AMENDMENT NO. 1 JUNE 2024

**IS 17434 : 2020 APPROVAL OF A CLOSE-COUPPLING DEVICE (CCD) AND
VEHICLES WITH REGARD TO THE FITTING OF AN APPROVED TYPE OF CCD**

FIG. 4 LAYOUT FOR CIRCULAR MOVEMENT WITH TANGENTIAL PROJECTION-VEHICLE

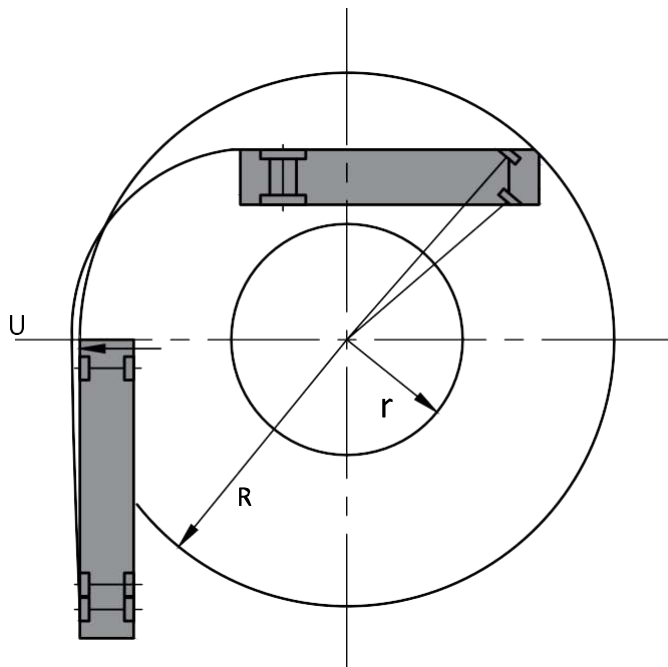
(Page 9, Annex C, Fig. 4) — Substitute the following for the existing:

R = 12.5 m (Vehicles having two axles)

R = 14.0 m (Vehicles having more than two axles)

r = 5.3 m, U = 0.8 m, *Max*

FIG. 5 LAYOUT FOR CIRCULAR MOVEMENT WITH TANGENTIAL PROJECTION-TRACTOR

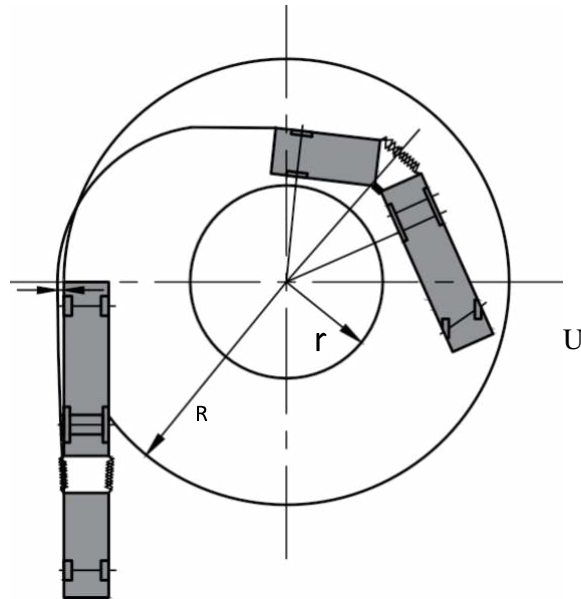
(Page 7, clause C-3.4, line 8) — Substitute ‘Fig. 4 and Fig. 5’ for ‘Fig. 4’.

(Page 9, Annex C, Fig. 4) — Insert the following after Fig. 4:

$R=12.5$ m (Tractor having two axles)

$R=14.0$ m (Tractor having more than two axles)

$r = 5.3$ m, $U = 0.8$ m, *Max*
